Application for Works Approval

Works Approval Number	W6639/2022/1
Applicant	Yara Pilbara Nitrates Pty Ltd
ACN	127 391 422
File number	DER2021/000662
Premises	Yara Pilbara Nitrates TAN Plant Village Road BURRUP WA 6714 Legal description Part of Lot 3017 on Deposited Plan 50979 Certificate of Title Volume 2784 Folio 568 As defined by the premises map and coordinates in the issued works approval
Date of report	10 August 2022
Decision	Works approval granted

Figure 2: Evaporation pond freeboard and spillway

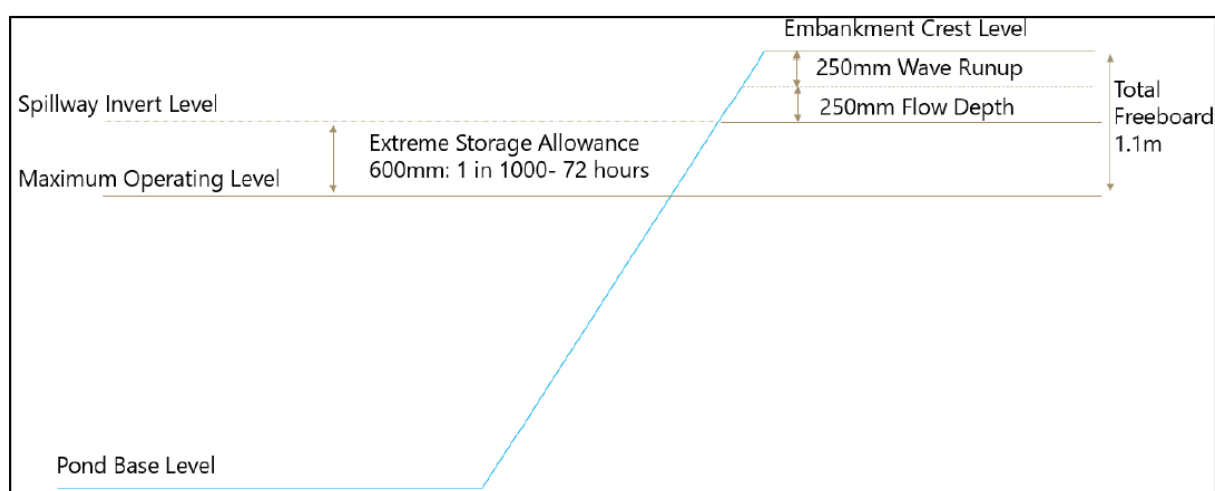
ANCOLD 2019 requirements for the design storage allowance above the pond maximum operating level (MOL) for a High C Consequence Category dam informed the pond embankment design. Bureau of Meteorology (BOM) Rainfall Intensity-Frequency-Density (IFD) curves for Karratha were used to determine key rainfall events. The resulting design storage allowances which were adopted for the evaporation pond design are detailed in Table 2 and illustrated in Figure 2 below. The design includes a 600 mm freeboard (to the spillway invert) to provide capacity for extreme storm storage in a 1 in 1,000 year AEP 72 hour rainfall event (619 mm). While the freeboard is slightly less than the design rainfall, it is considered adequate given the maximum recorded monthly rainfall is 348 mm for the area over a 50-year period (BOM 2022). Additionally, the design includes a 500 mm allowance above this to account for wave run up to prevent spillage during a storm surge event.

The embankment design includes an emergency spillway on each pond, set at the 600 mm freeboard level, to mitigate the risk of embankment damage during extreme weather events (i.e. a 1 in 1,000 year AEP 72 hour rainfall event). The spillways have been designed to convey 0.75 m³/s which is the flow associated with a 1-hour duration of Probable Maximum Precipitation (PMP) over the pond area less the 1-hour duration of 1: 1,000 event.

- Installation of a spillway on each pond to minimise the risk of overtopping during extreme rainfall events.
- The ponds will be operated to a maximum water level which provides at least 0.6 m freeboard to the spillway inverts to provide extreme storm storage based on a 1:1,000 year AEP 72 hour rainfall event and the ponds will have a total freeboard of 1.1 m to prevent overtopping due to wave run-up during an extreme storm event.
